ORDINANCE NO. O2019-05

AN ORDINANCE APPROVING SPECIAL USE PERMITS FOR A PLANNED UNIT DEVELOPMENT FOR THE ENTIRE PROPERTY, THE SITE WORK PHASE, AND PHASE I AND A FINAL PLAT OF SUBDIVISION FOR THE EVERTON MIXED-USE DEVELOPMENT AT THE SOUTHEAST CORNER OF ROUTE 59 AND IVAN ALBRIGHT STREET

Re: Everton Subdivision
Illinois Route 59 and Duke Parkway
Final Engineering Plan Review
ERA Project No. 632.752

Re: Final PUD Site Plan for Everton MI Homes
Traffic Review
Project No. 632.761

FINAL PUD PLAN

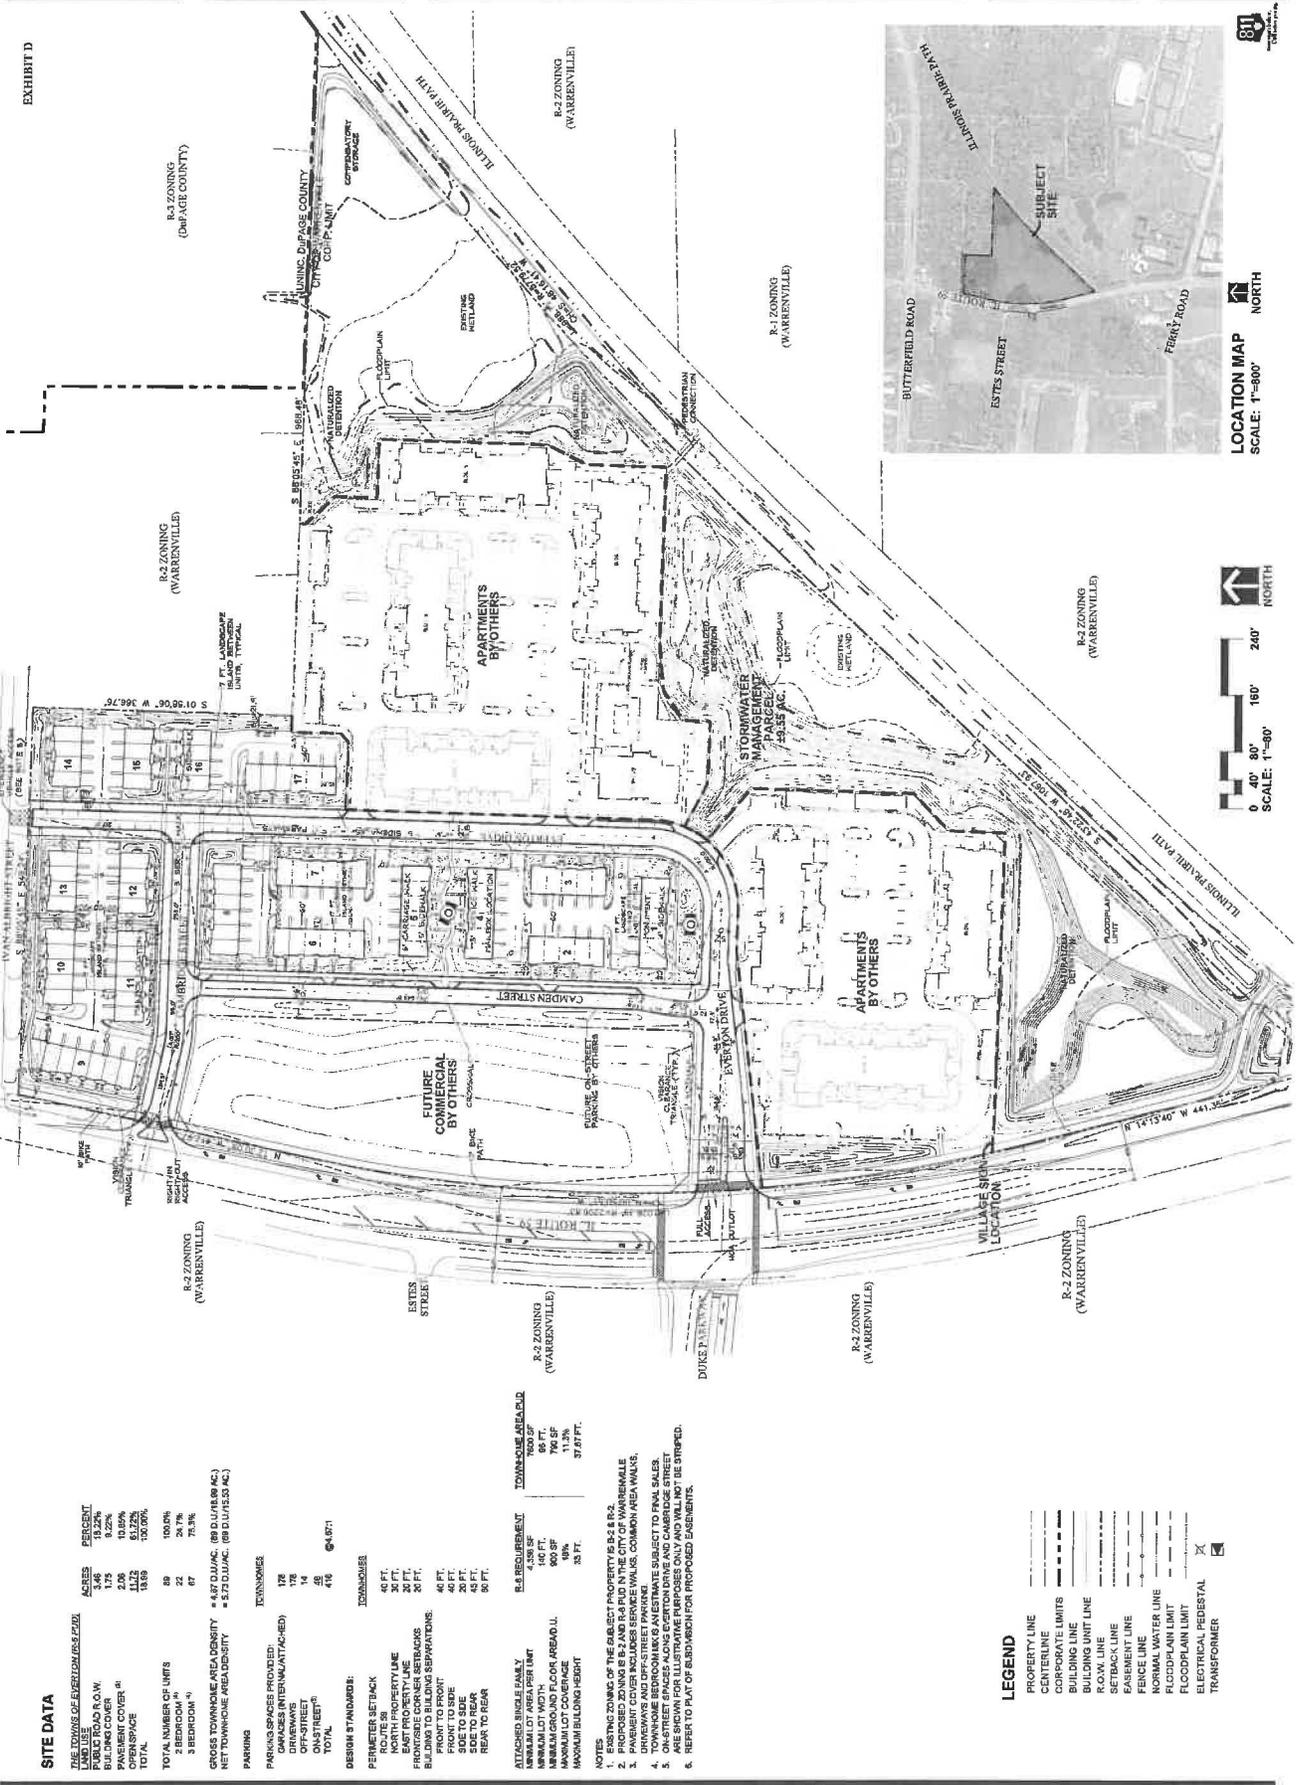
12. Path Connections. The Applicant shall coordinate with and secure necessary permits from the DuPage Division of Transportation to construct path connections to the Illinois Prairie Path as illustrated on the Final PUD Plan.

13. Phasing. Townhouse Buildings 2 and 6 as illustrated on the Final PUD Plan shall not be built prior to Camden Street construction.

FINAL PLAT OF SUBDIVISION

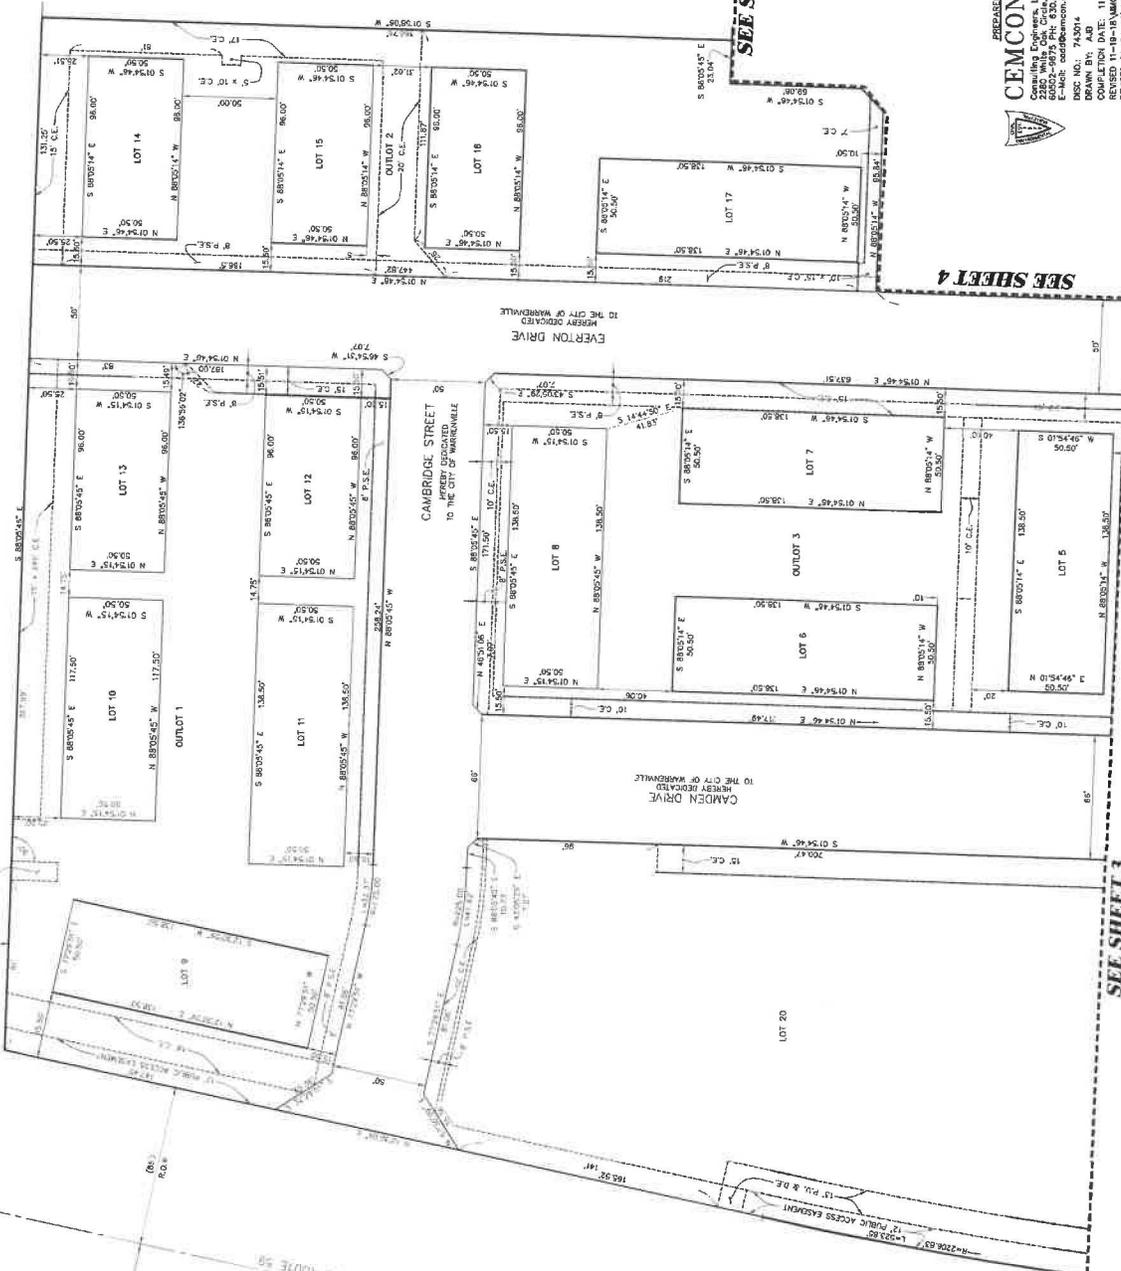
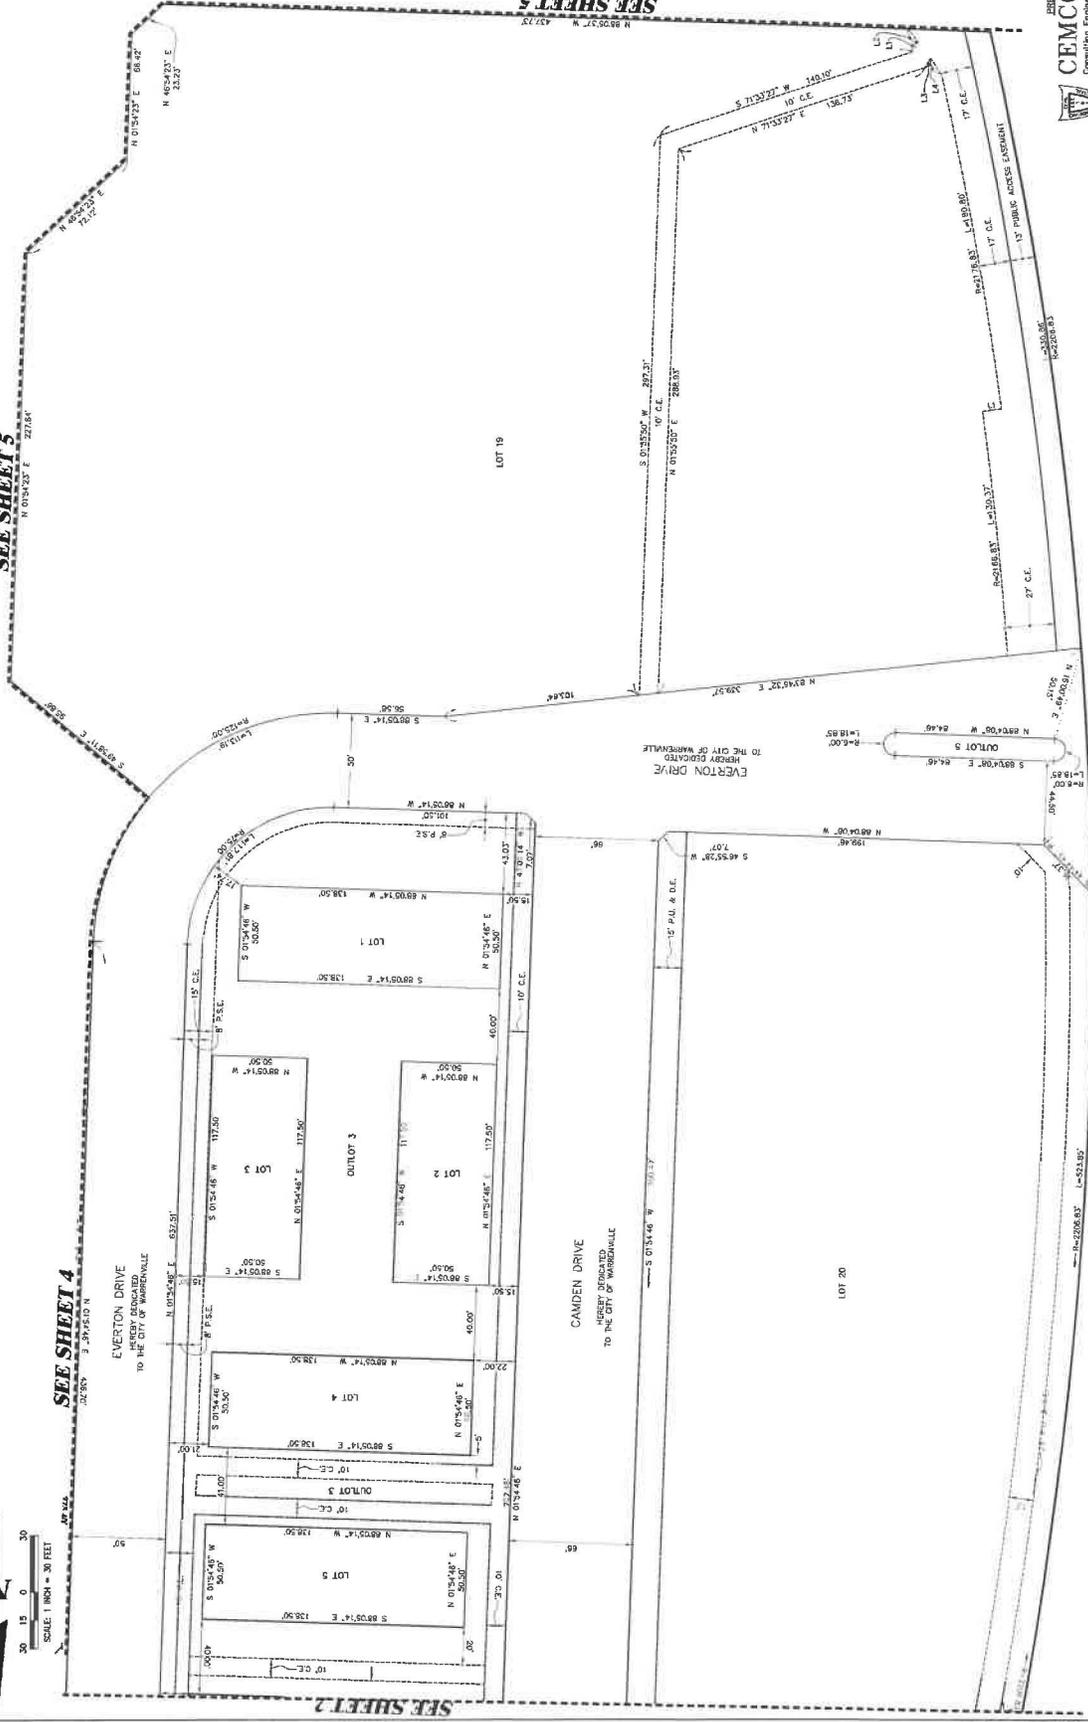
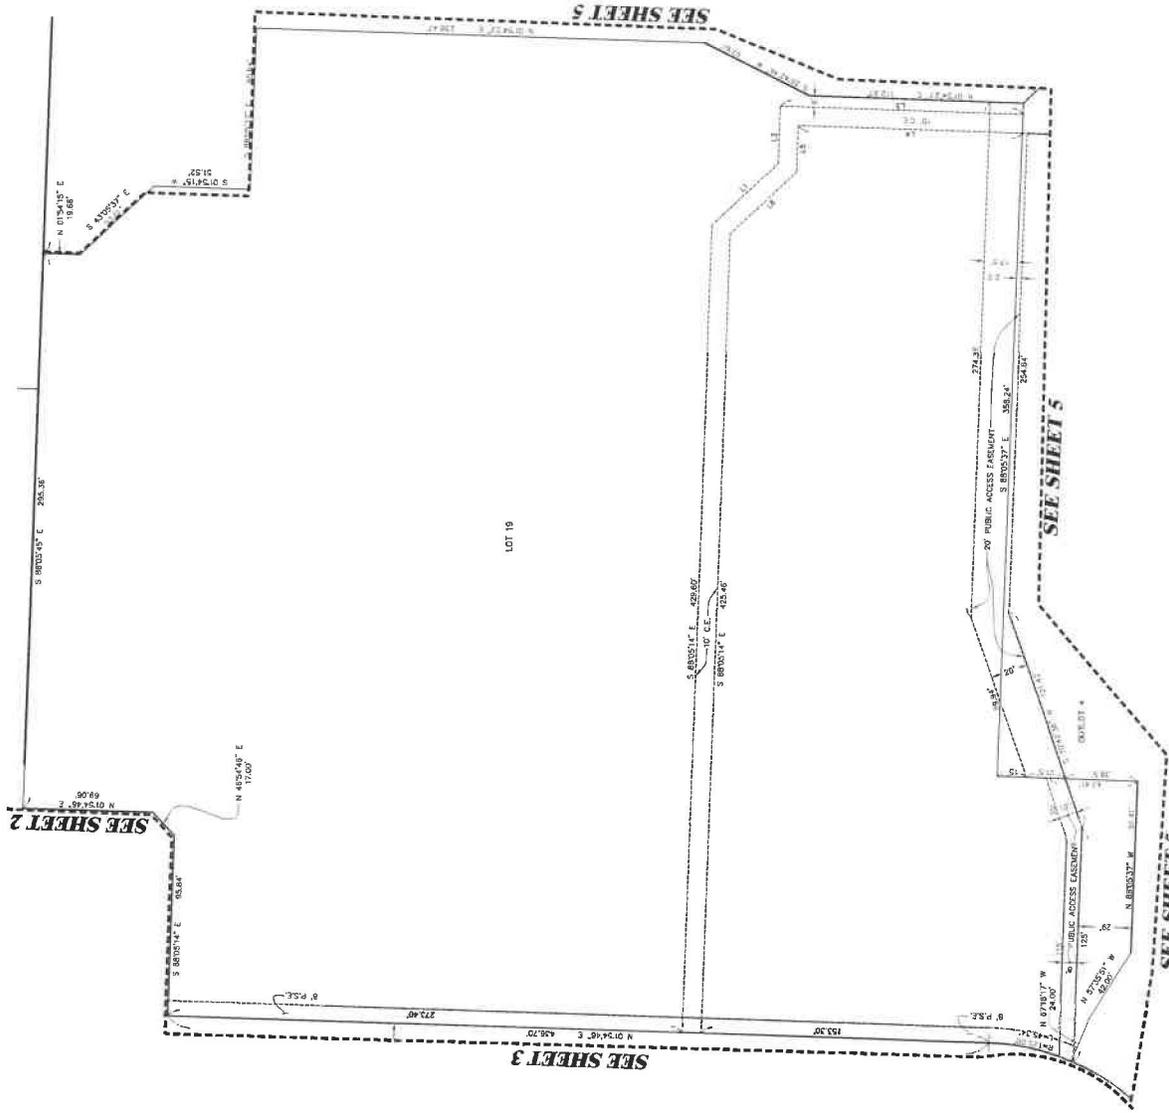
1. **New Comment:** Include existing and proposed zoning designation (the approved zoning is outlined in Ordinance #2018-36).
2. **New Comment:** Include existing address(es) of the property.
3. **New Comment:** Outlot 5 shape should match the engineering plans.
4. **New Comment:** Add the sidewalk along Building 19 to the Plat as a P.S.E
5. **New Comment:** Camden Drive should be Camden Street to match plans.
6. **New Comment:** Revise the City Easement provision to "...BUT THE PREMISES MAY BE USED FOR PAVED AREAS, DRIVEWAY, SIDEWALK, AND CITY MONUMENT SIGNS."
7. **New Comment:** See Plat markup for additional comments (attached).

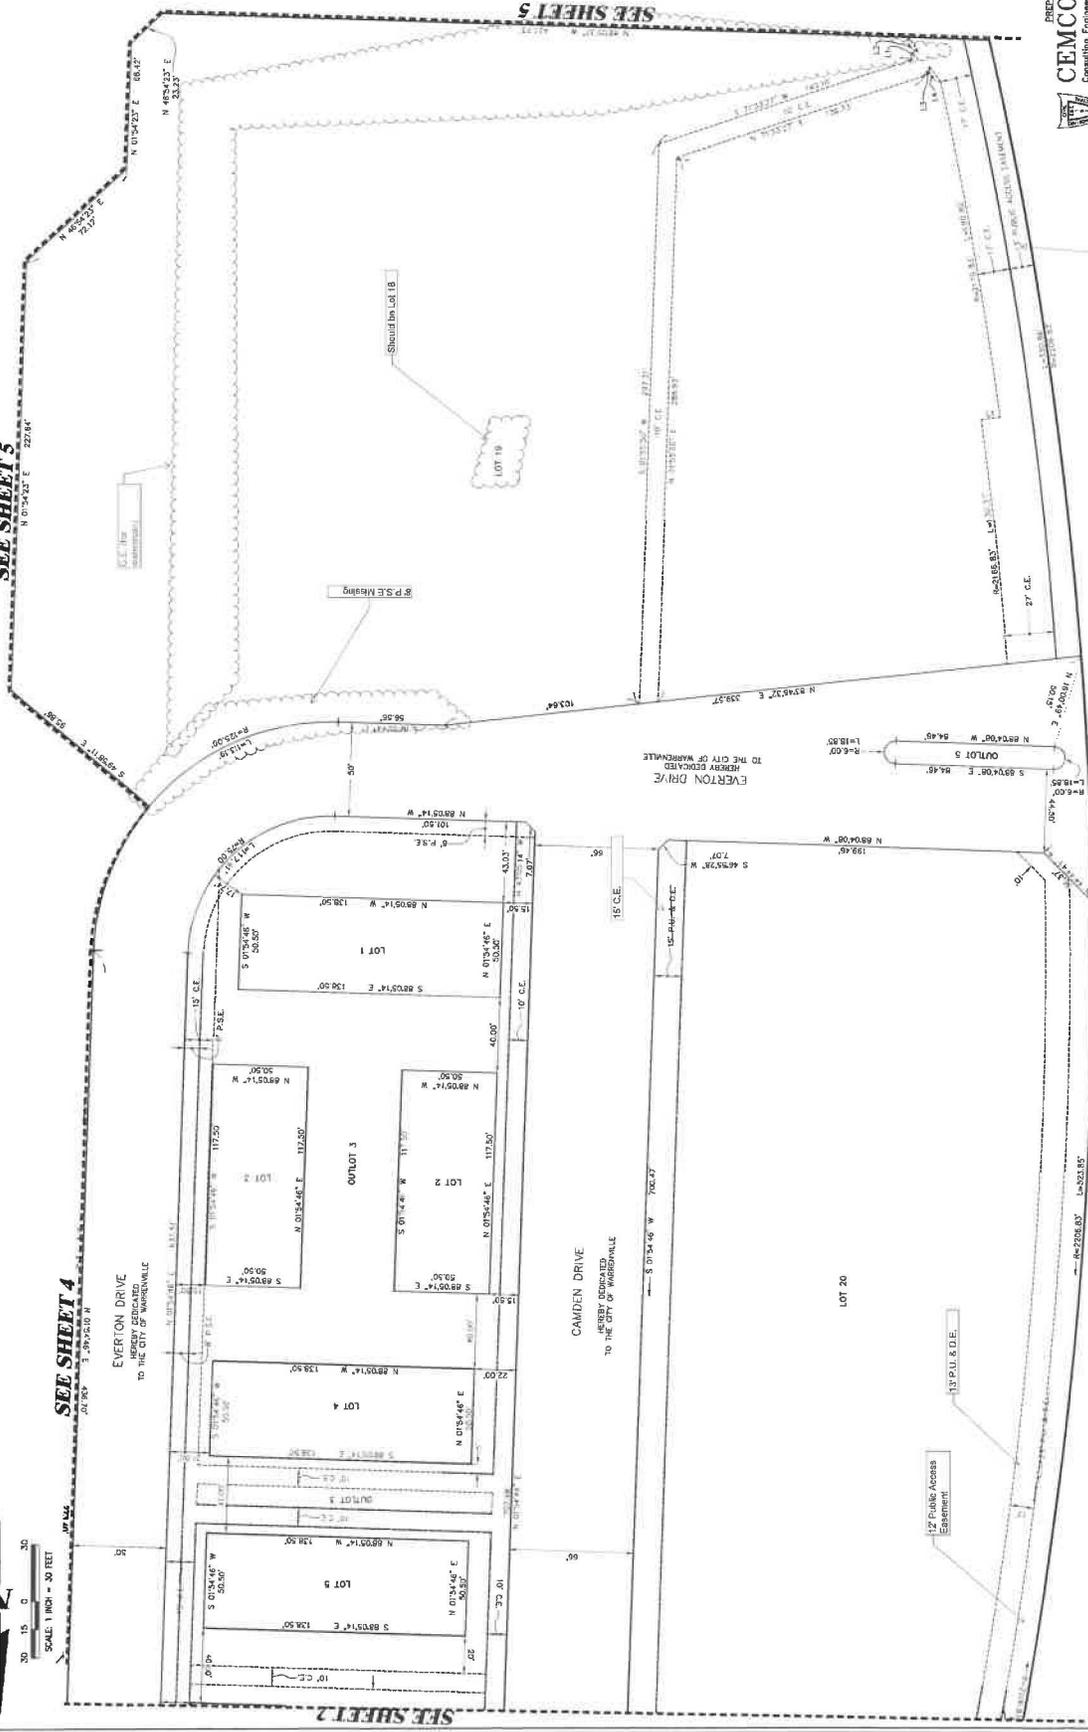
Is there a reason why this is a 12' public access easement instead of a 10' easement? North arrow 127'
